MODIFICATION ASSESSMENT REPORT MOD 7675

Modification to the approved Stage 1B mountain bike trails, Thredbo Alpine Resort, Kosciuszko National Park

Modification (2) of DA 6571

June 2016

Figure 2: Start of new alignment of Trail 12, noting the approved Trail 12 alignment was located on the opposite slope (Source: Department site inspection photograph)

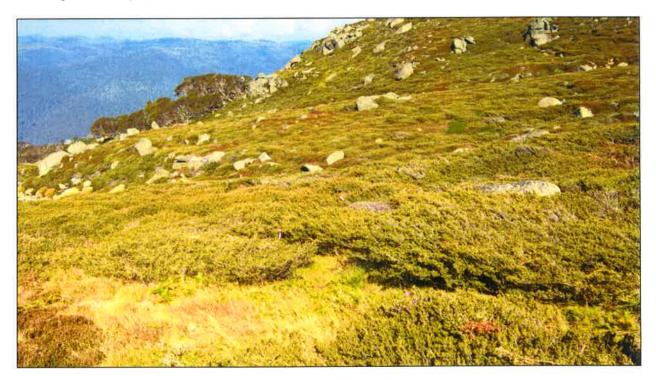
- reduces the slope of the trail and overall average grade;
- commences further along Trail 13 and therefore traverses more across contour at a longer length, requiring the installation of two bridges across Merritts Creek (Figure 2). The bridges will be the same as approved for Trail 13 bridges, constructed using the same method; and
- although longer than the approved trail, the approved trail was designed to also use the side
 of the Summer Road down to the start of the Downhill and Flow trails, so its actual length
 would have been more likely 510 metres rather than 370 metres as shown below. Therefore
 the difference in the two trails would be more likely around 50 metres.

Figure 3: Proposed alignment of mountain bike trail (green line) compared with approved alignment (yellow line) (Source: Applicant's MOD documentation)

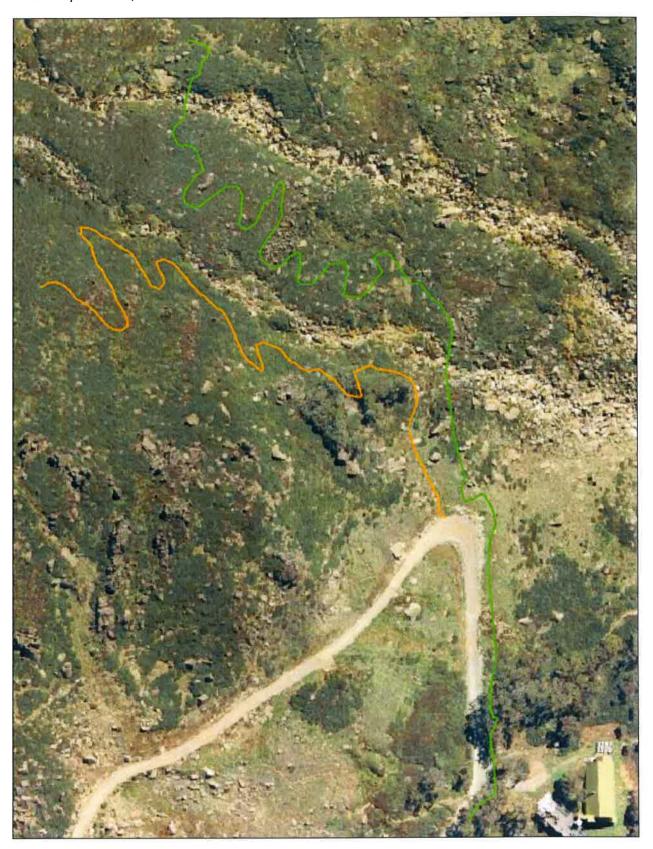
The OEH advised that the modified alignment is preferable when compared to the approved Trail 12, however requested further exploration of opportunities to reduce the number of switchbacks and the overall length of the trail. In addition, OEH requested a buffer be provided between the trail and the edge of the boulder field habitat that contains Podocarpus heath (potential habitat for the Mountain Pygmy Possums).

Comments received from the OEH, support the proposed realignment however requested a review of the number of switchbacks and recommending that a 5 metre buffer be provided between the trail and the boulder field, which has potential to be used by the Mountain Pygmy Possum.

The Applicant has previously provided justification for the number of switchbacks, however has agreed to minimise the number of switchbacks for the final alignment and will also review the location of the trail to provide a suitable distance up slope to the boulder field. It is noted that in accordance with the approved conditions, the final alignment of the trail is to be endorsed by the

- reduces the extent of cut and vegetation loss compared to that of the original alignment;
- provides an improved rider experience through a reduction in steeper sections; and
- has considered the environmental in terms of proximity to sensitive vegetation community and bridging of watercourses.
